Re: 3BM-COR1521 Notification of Modification to Water Supply Intake

As per Part E, Item 2 of Water Licence 3BM-COR1521, the Government of Nunavut, Department of Community and Government Services (GN-CGS) on behalf of the Hamlet of Coral Harbour (Licensee) is notifying the Nunavut Water Board (NWB) of a proposed modification to the location of the water supply intake in Coral Harbour.

Figure 2: Map of Current and Proposed Intake Locations with respect to Water Reservoir

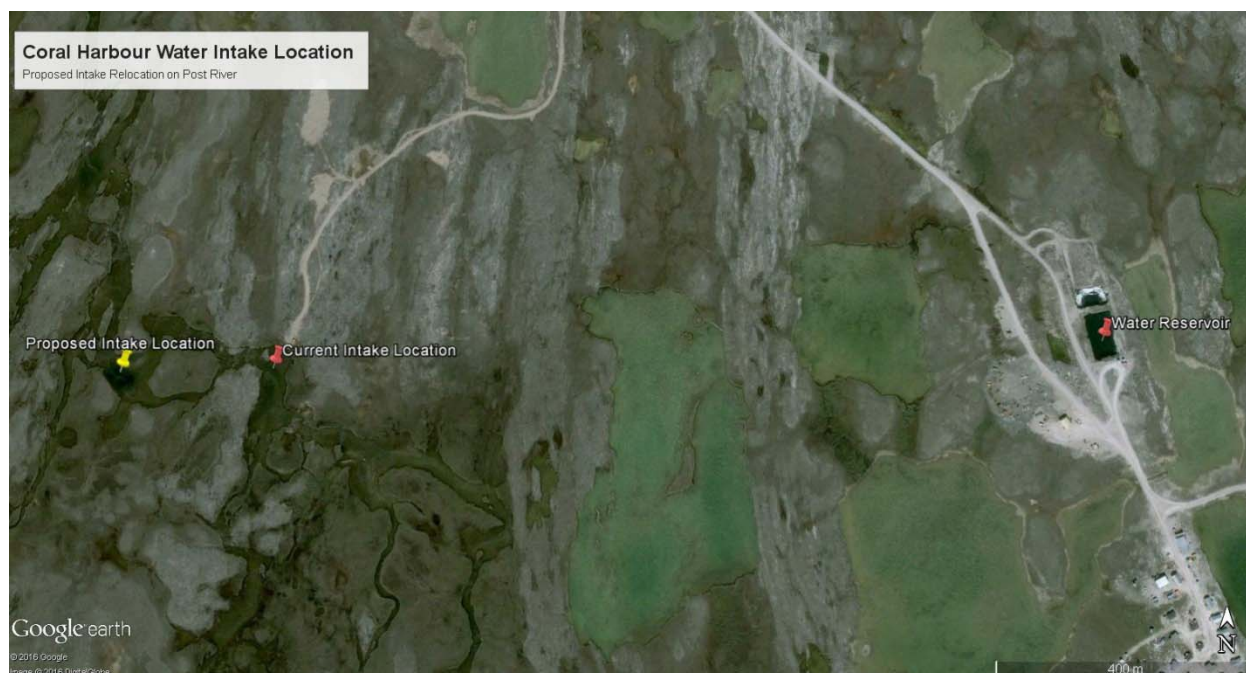
The Licensee is notifying the NWB of a proposed modification to the location of the water supply intake to approximately 245 meters upstream of the current intake. The proposed intake location is significantly deeper with a depth of approximately 10 feet (3.05 m). The image below displays the current and proposed intake locations with respect to the water reservoir. The darker water colour at the proposed intake location is due to the greater water depth.

Relocating the water supply intake upstream to a deeper location in Post River would extend the timeframe that water can be pumped from the river, reduce the amount of sediment being captured from the bottom of the river, and decrease the likelihood of rocks being sucked into the pump. Moving the intake location will also reduce the likelihood of an emergency situation occurring in an extremely dry scenario when water depths are not sufficient for pumping and the Hamlet cannot refill the reservoir. The proposed intake location is not anticipated to change the hydrological impact of pumping from Post River as the same intake screen, pump and water withdrawal rate will be used.
